Addendum No. 2
March 13, 2025

Project: Brandon Valley Middle School Addition
Brandon, South Dakota
Project #3090

Architect: Architecture Incorporated

9.21

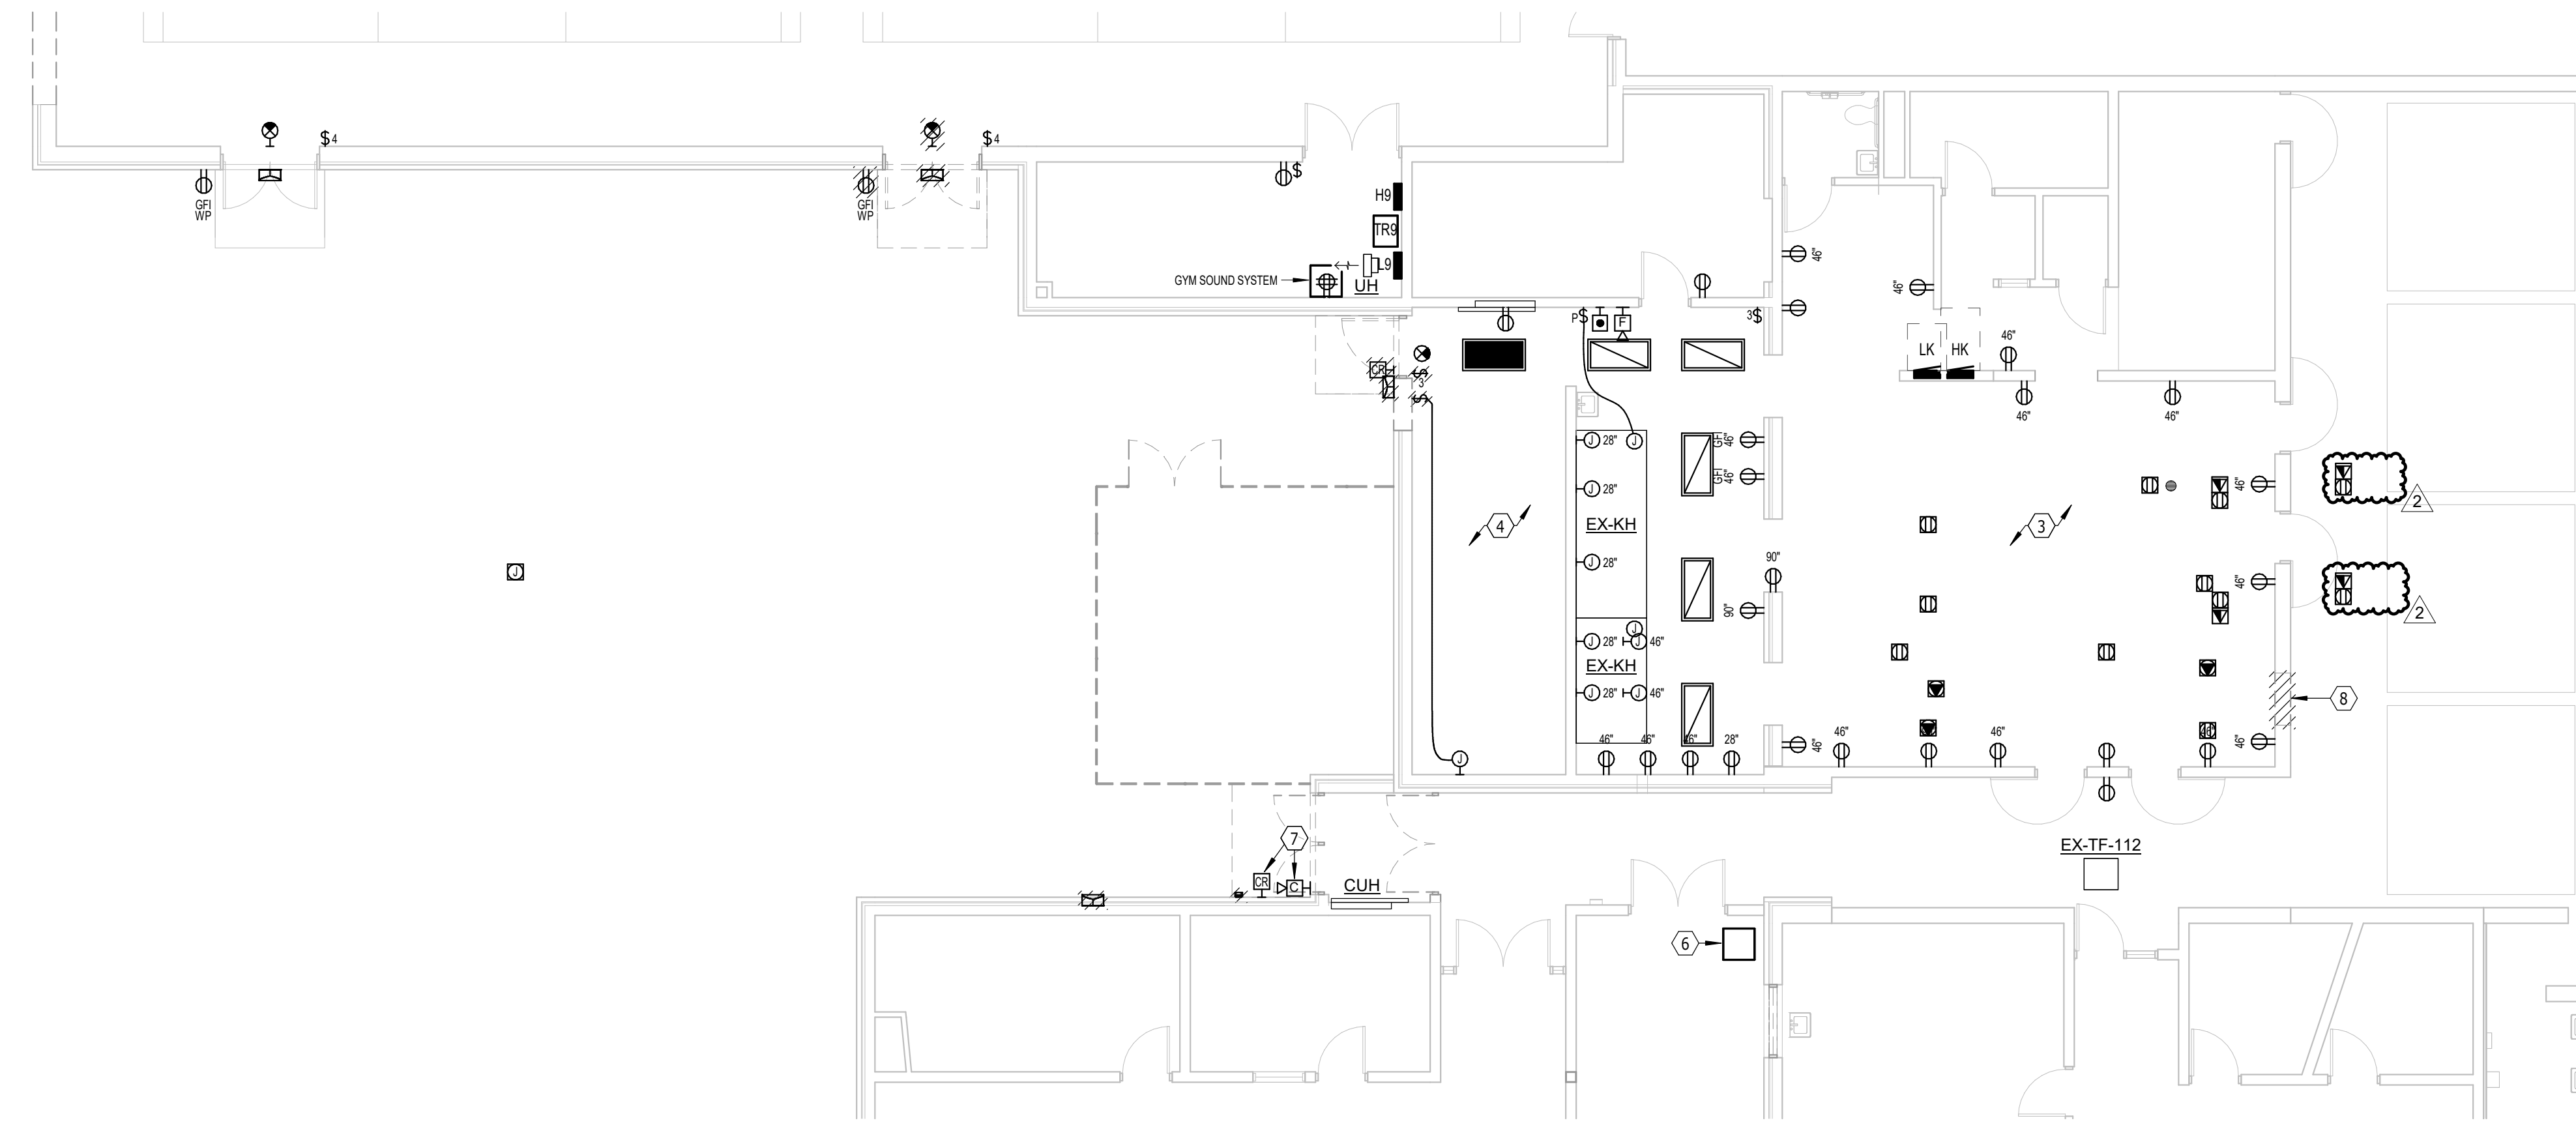
- 2) SHEET 9.21 – FIRST FLOOR DEMOLITION PLAN – AREA A1 & A2 ELECTRICAL
 - a) Remove electrical note Tag #3 near floor boxes in COMMONS 121 in two locations as indicated in *revised* Sheet 9.21, *revision* dated 3-13-2025, attached to the end of this addendum; floor boxes are to remain.

9.30-A1

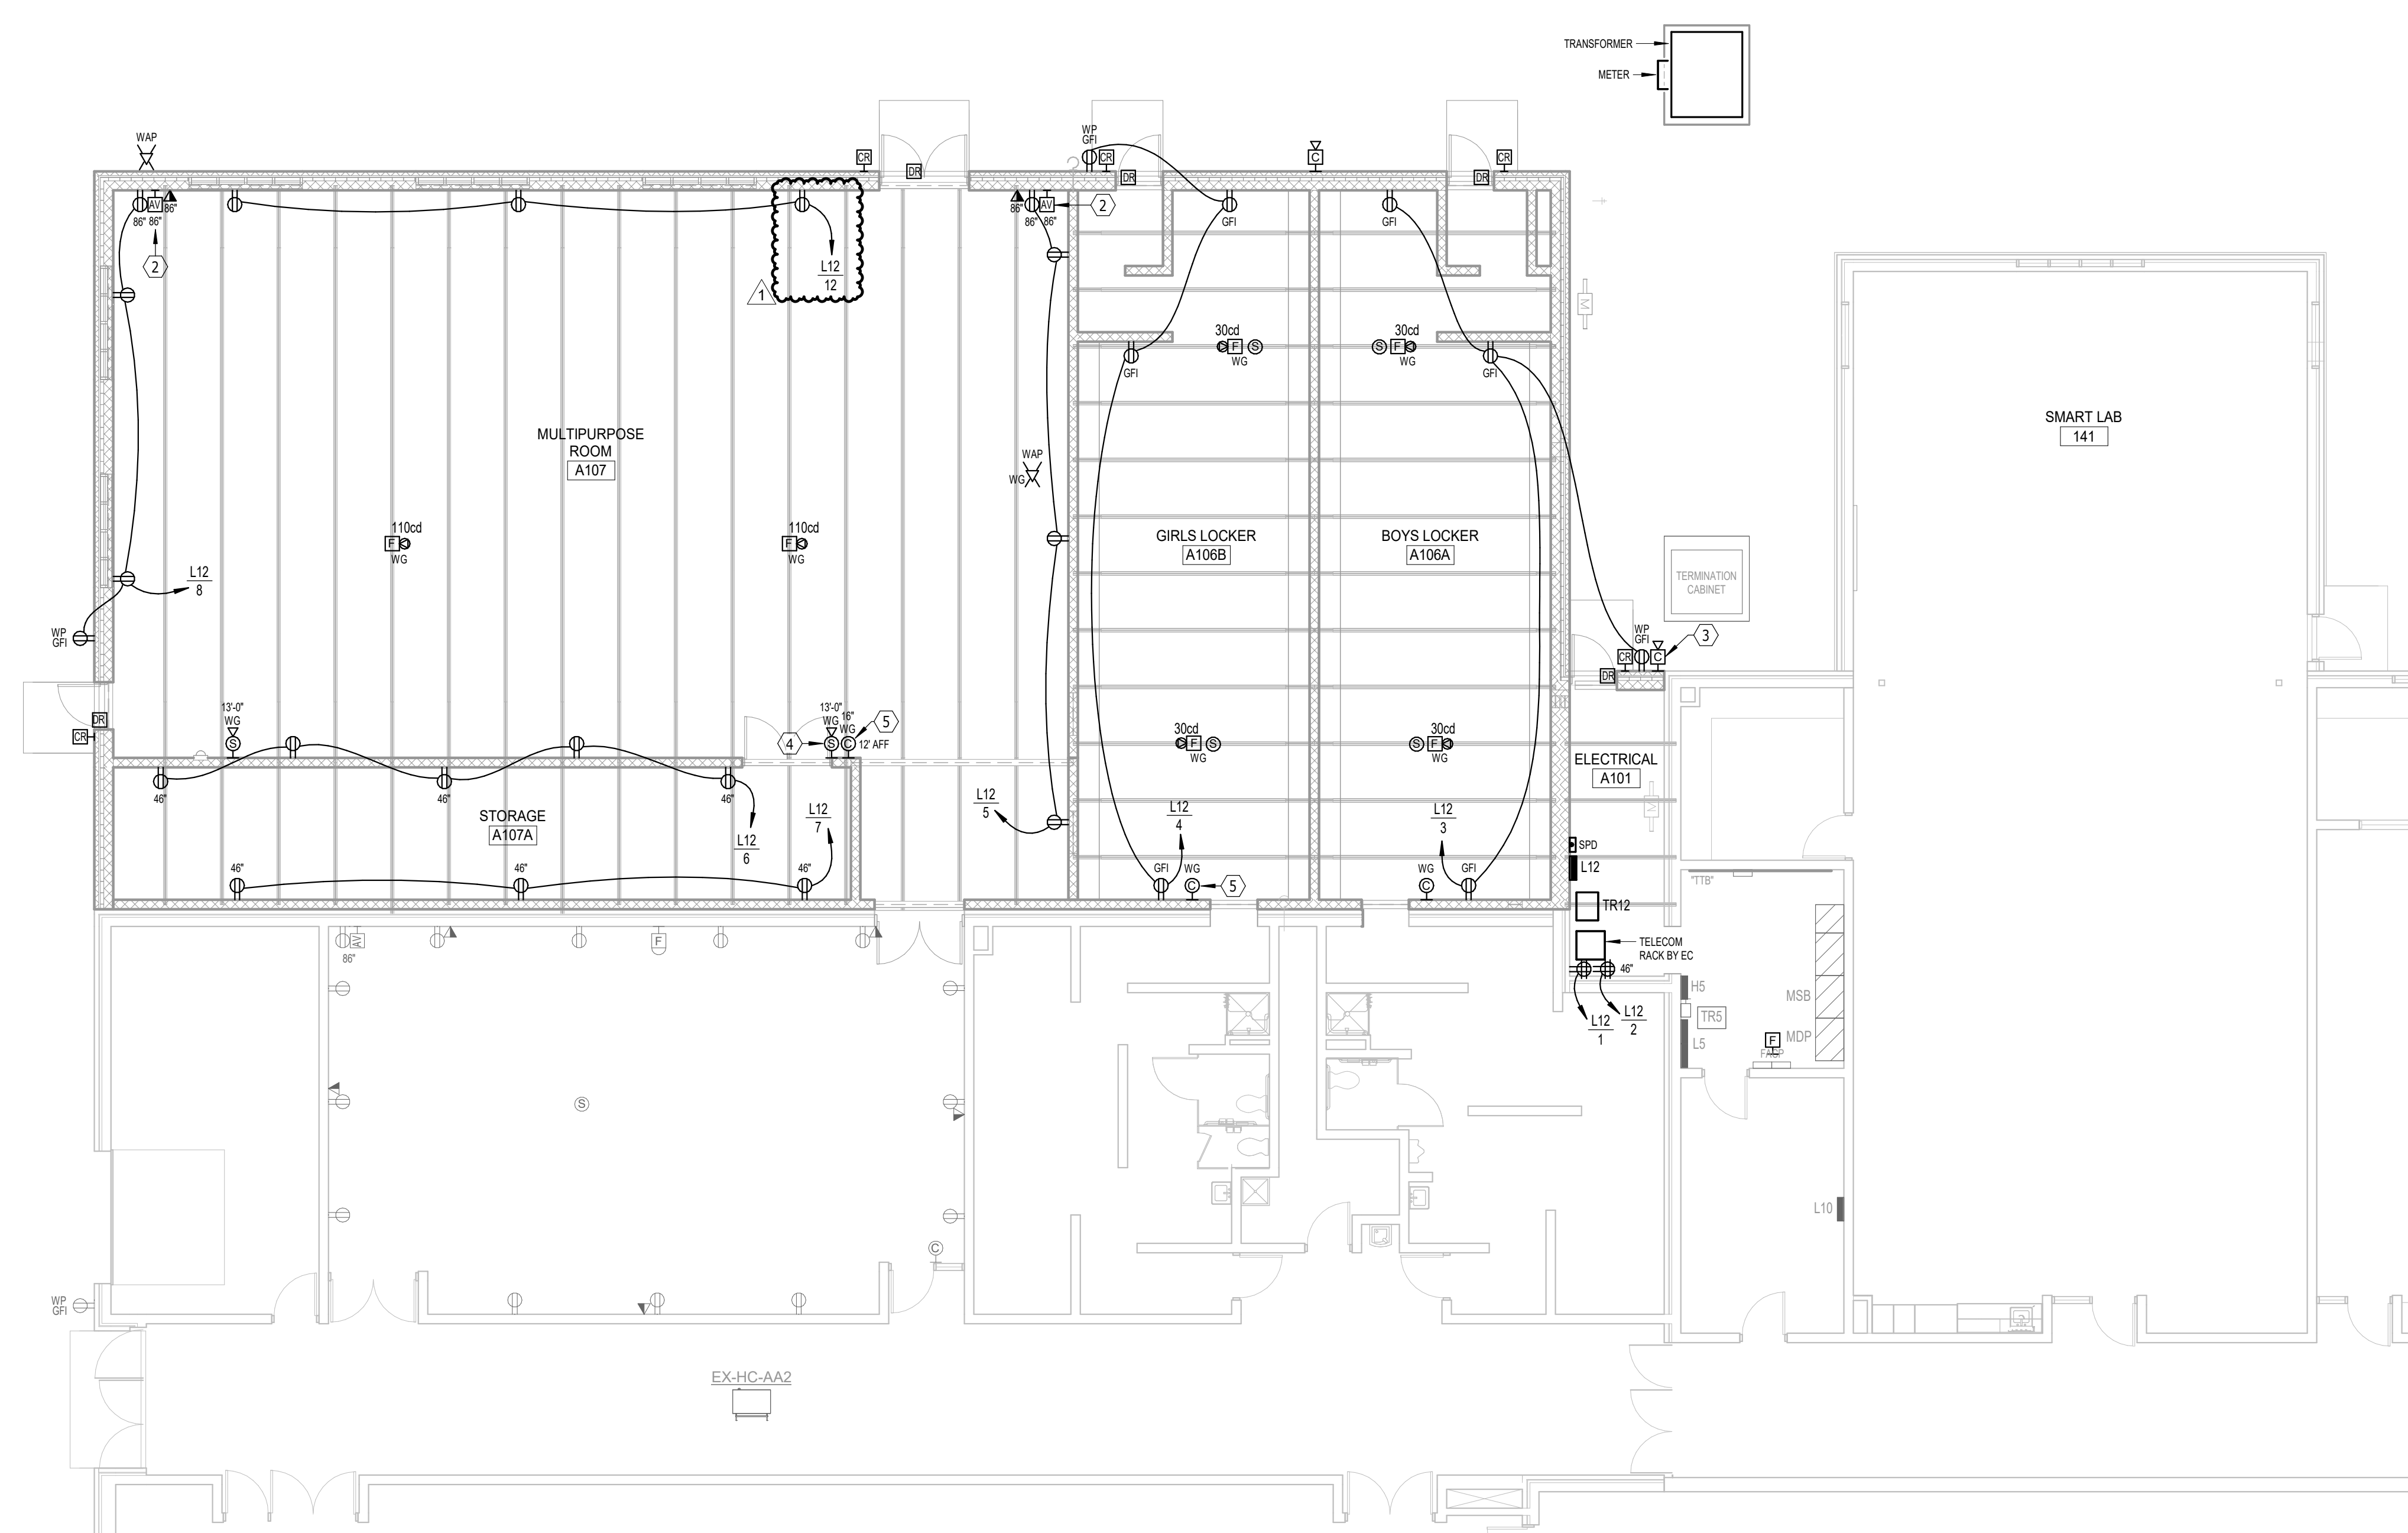
- 3) SHEET 9.30-A1 – FLOOR PLAN – AREA A1 – ELECTRICAL
 - a) Reference *revised* Sheet 9.30-A1, revision dated 3-13-2025, attached to the end of this addendum for following modifications:
 - i) Change (3) Type Y3 fixtures to Type Y2 on building exterior.
 - ii) Add homerun circuit to Panel L12/12 from 3 receptacles on north wall.
